# City of Alexandria, Virginia

## MEMORANDUM

**SUBJECT:** 2<sup>nd</sup> CONCEPT REVIEW OF 101 DUKE STREET  
BAR # 2020-00612

Figure 2: Previously submitted site plan

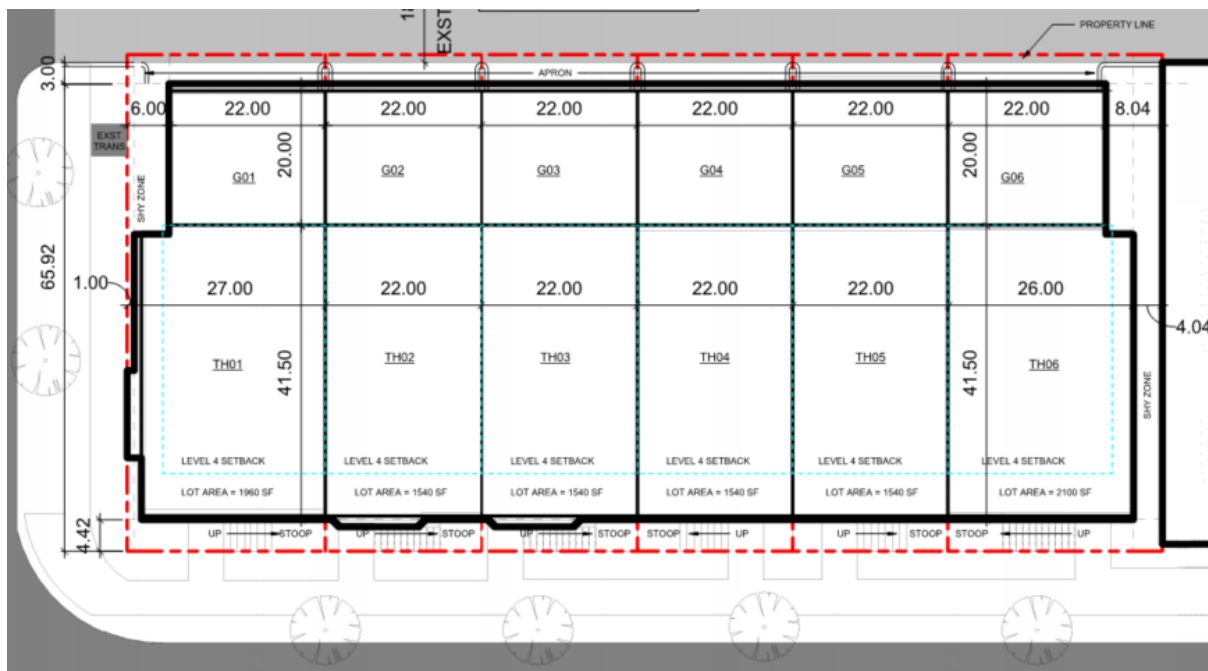
Under the previous design for the project, the plan consisted of a continuous row of 6 townhomes with townhouse one at 27’ wide, townhouse two through five at 22’ wide, and townhouse 6 at 26’ wide (Figure 2). Each of the townhomes features a single story 22’ wide by 20’ deep attached two car garage with roof terrace located at the west side of the site. In response to comments that the design felt too large, the applicant has broken the massing into two separate parts. Under the current design, the building is broken into two equal groups of three townhomes that are all 22’ wide with an approximately 7’ wide pedestrian alley separating the buildings (Figure 3). This alley is reminiscent of the traditional narrow alleys found throughout both the residential and formerly industrial portions of the historic district.

Figure 8: Section through proposed building and adjacent hotel

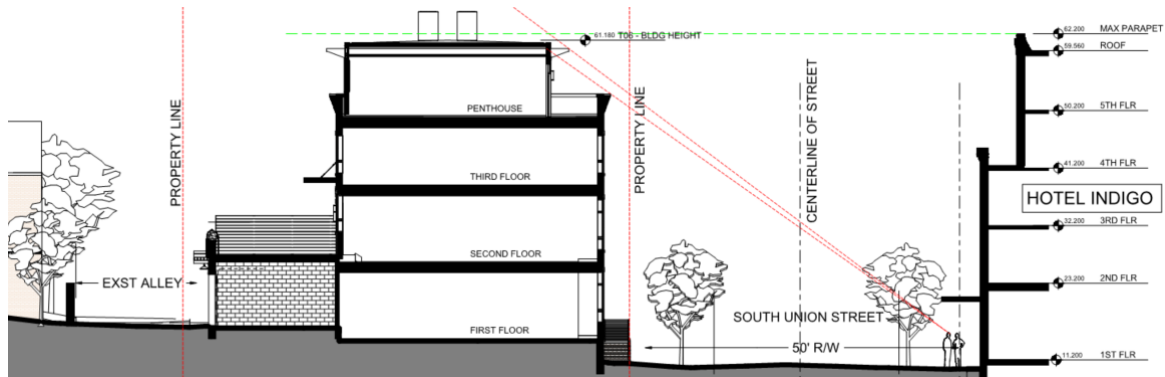
The Board had concerns regarding the overall height of the proposed project, specifically noting that given the proximity of this building to neighboring residential properties, it should be shorter than the hotel on the opposite side of Union Street. Through the reconfiguration of the building interior, the applicant has been able to reduce the overall height in excess of 3', bringing the top of the tallest portion of the proposed building lower than the neighboring hotel (Figure 8).

## TH GRADING SECTIONS

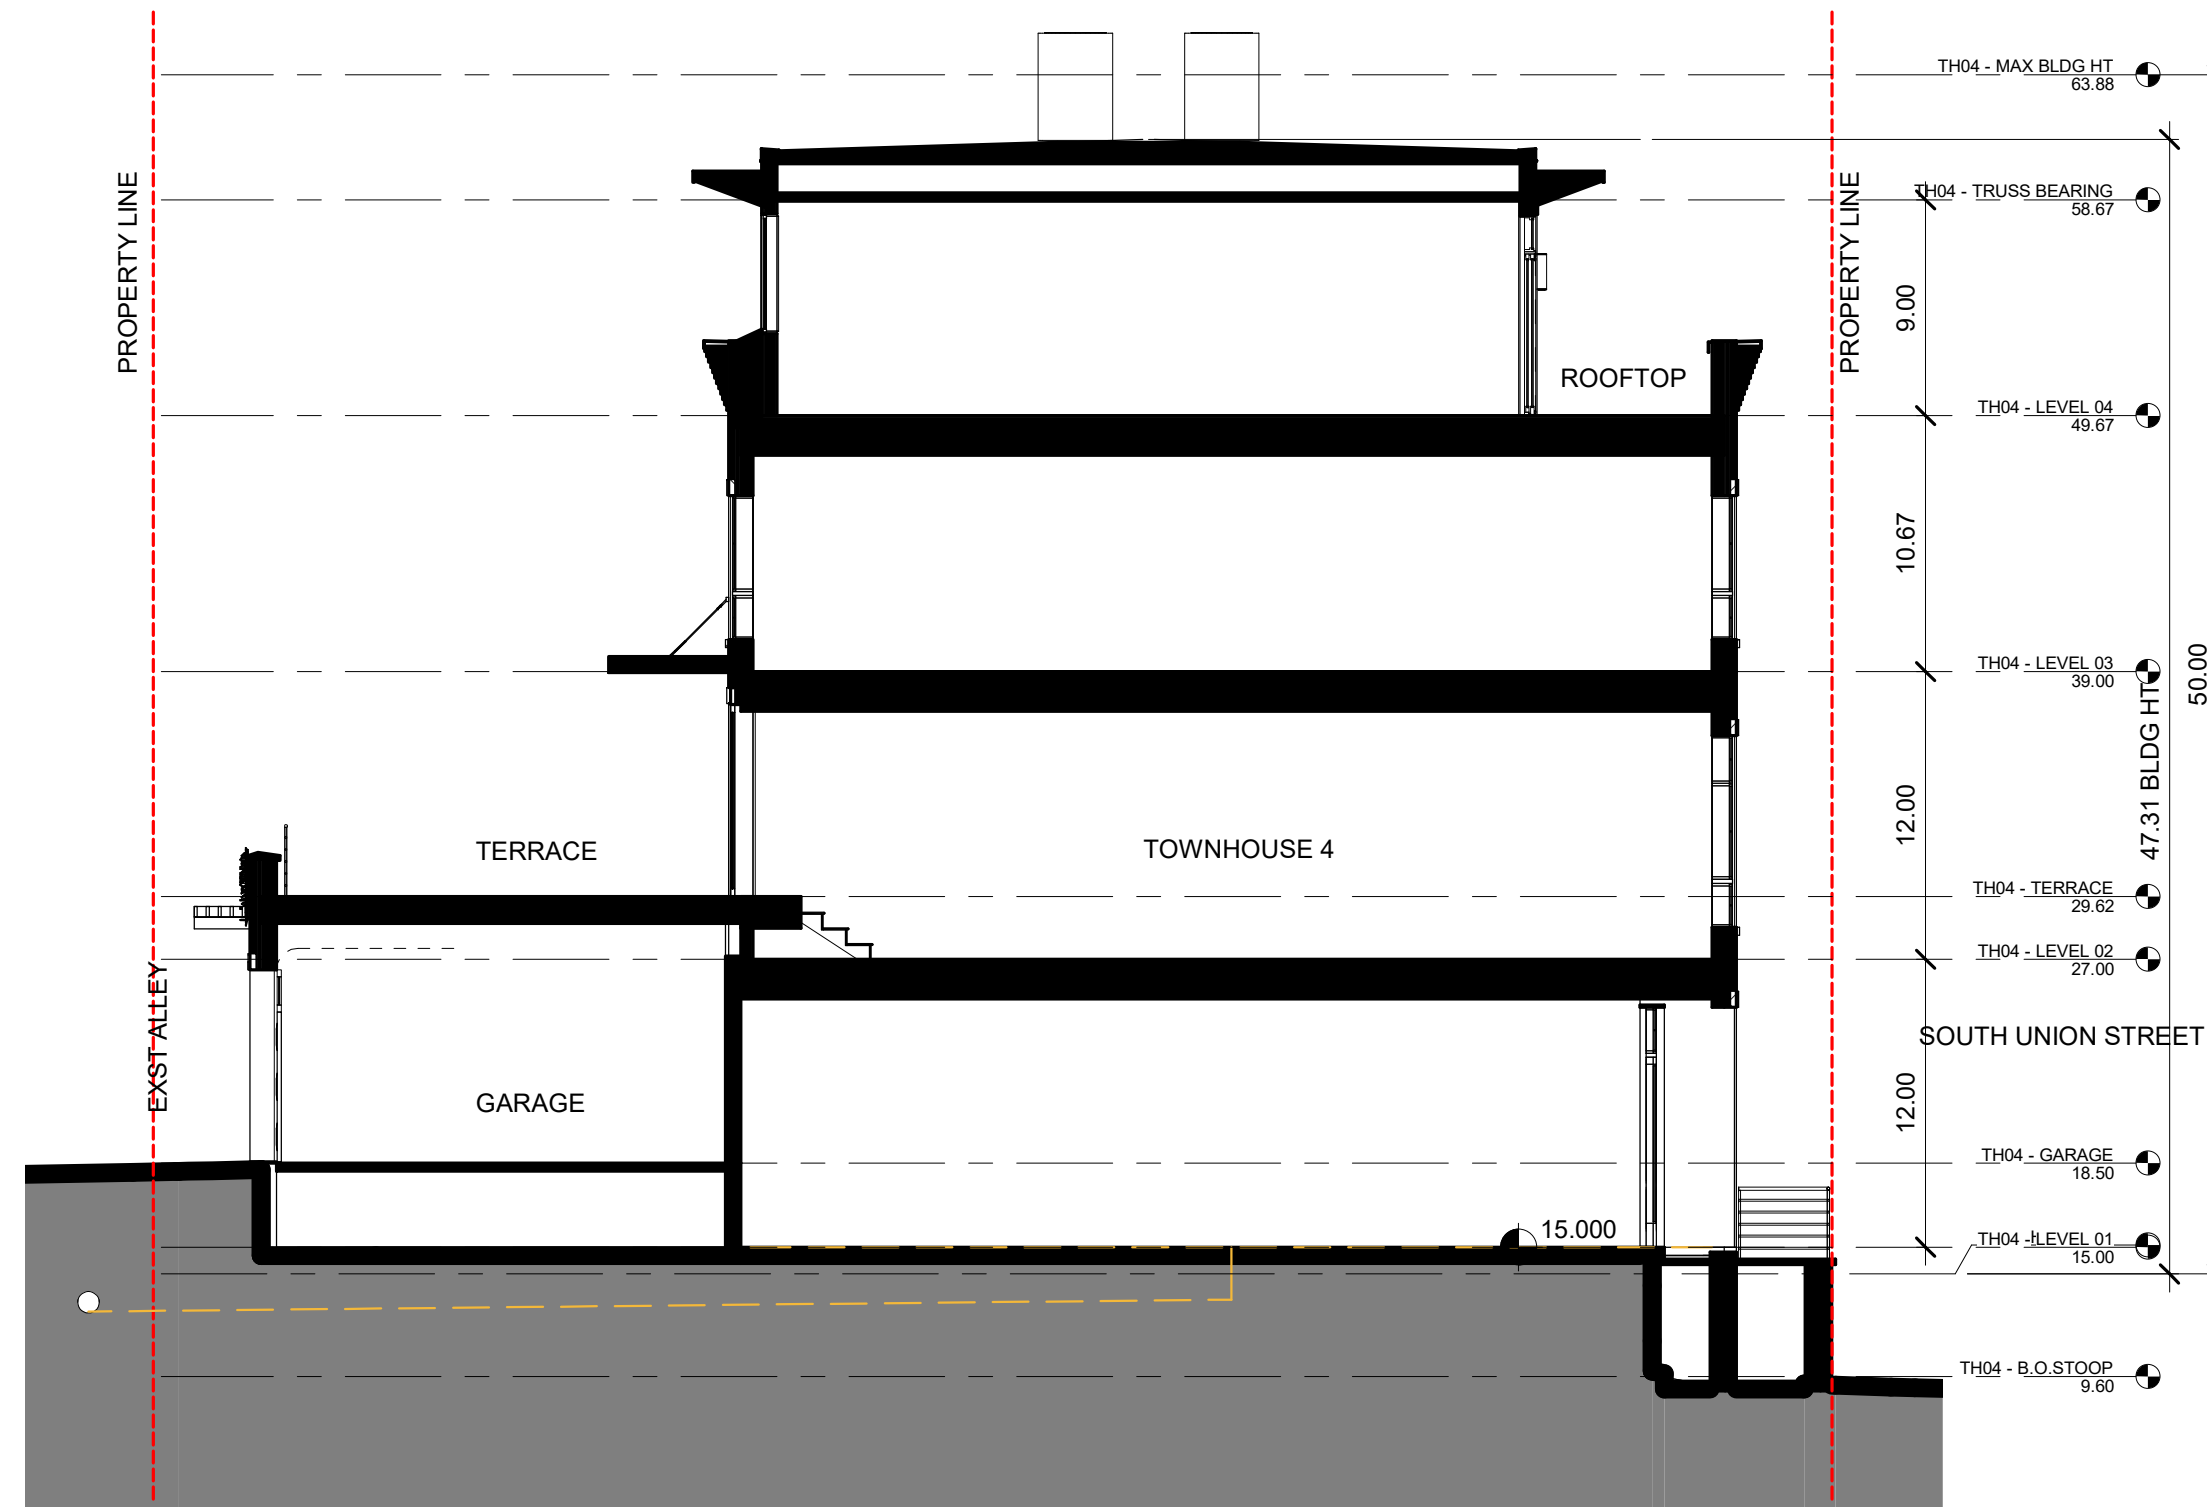
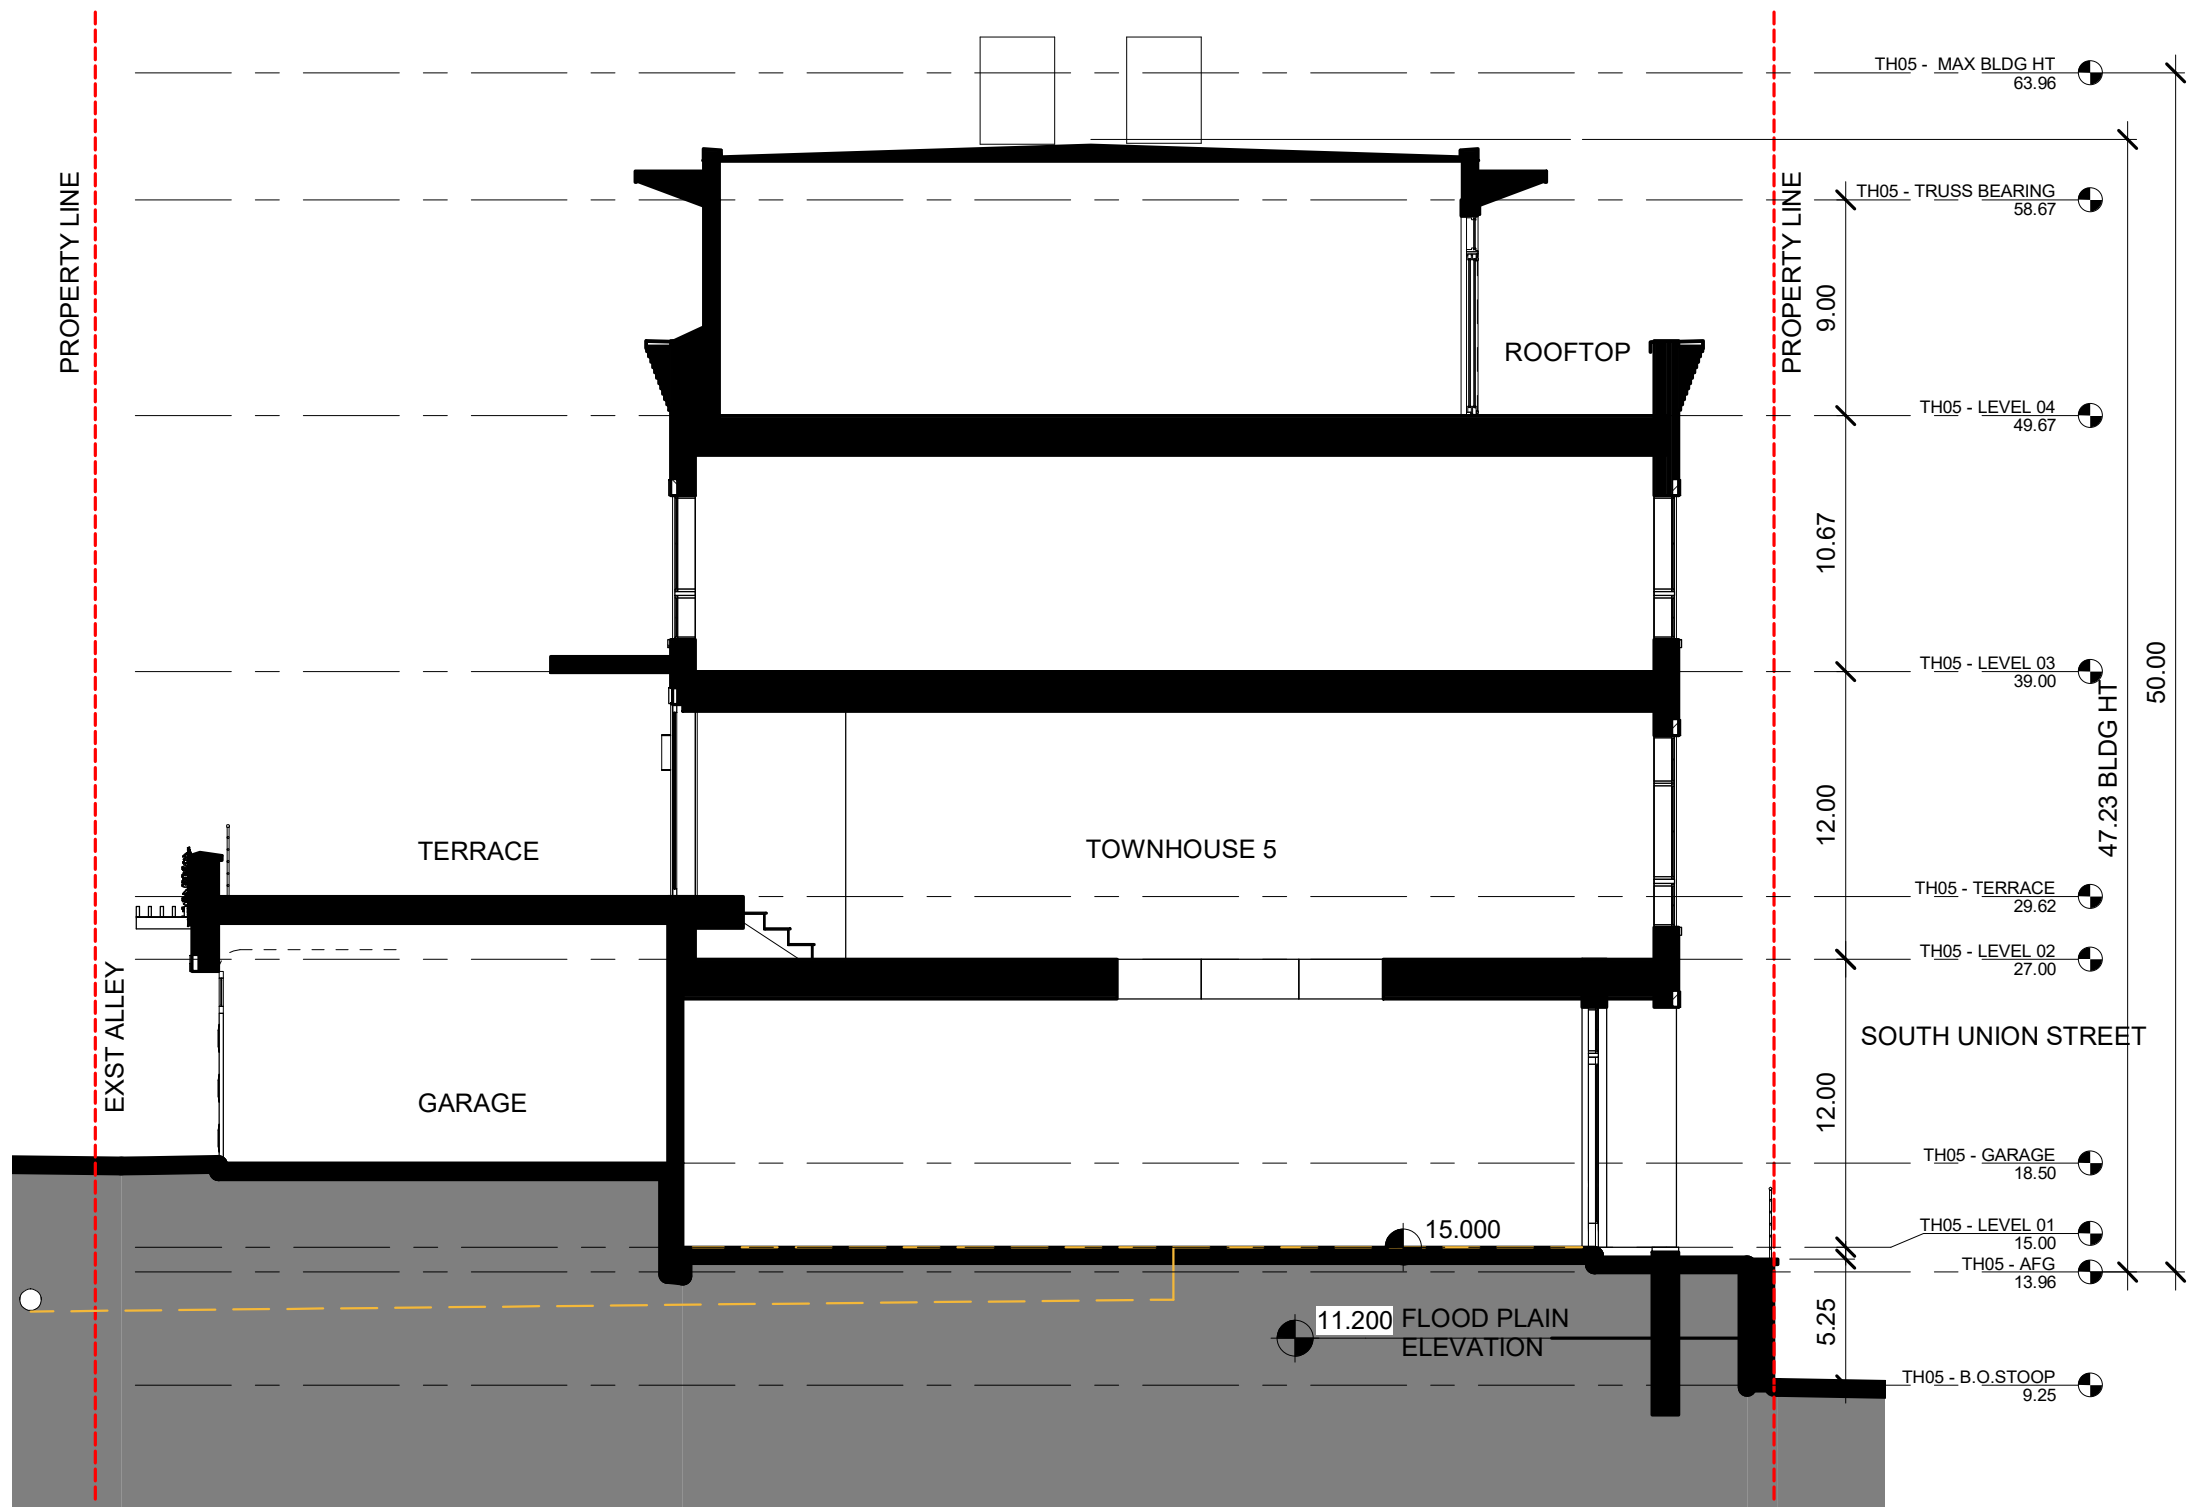
The previous design included entry stoops that ranged in height above the Union Street sidewalk from 5' at the lowest point to 7' at the highest point. As was discussed at the previous hearing, Union Street is a vibrant pedestrian oriented street and the height of the entries made for an uncomfortable relationship with the sidewalk. The design team was able to modify the interior design for the building so that the height of the stoop is not entirely driven by the elevation of the garages at the rear of the site. Unfortunately, there are other existing site conditions that require an elevated entry for each of the townhomes. In the revised design the applicant is now achieving entry stoop heights that range from 3' at the lowest point to 6' at the tallest. These create a streetscape that is much more friendly to pedestrians and brings the living spaces closer to the level of the sidewalk.

The current design for the entry stoops shows brick walls with brick pavers and metal rails. While the height of the stoops above the adjacent grade has improved since the last submission, the current design is still somewhat imposing and monolithic. This element represents an opportunity to create a part of the building that engages the sidewalk and helps to bring the scale of the building to a more pedestrian level. It is quite common throughout the historic district to find entry stoops in a variety of different designs. In some cases, where there is an English basement configuration, the entrance to the basement apartment is through stairs below the entry. Staff suggests that the applicant consider options for the design of the entry stair that are similar to those found throughout the historic district (Figure 12). In addition, it may help to provide a variation of approaches based on the height of the stoop which will further serve to break up the overall massing of the building.
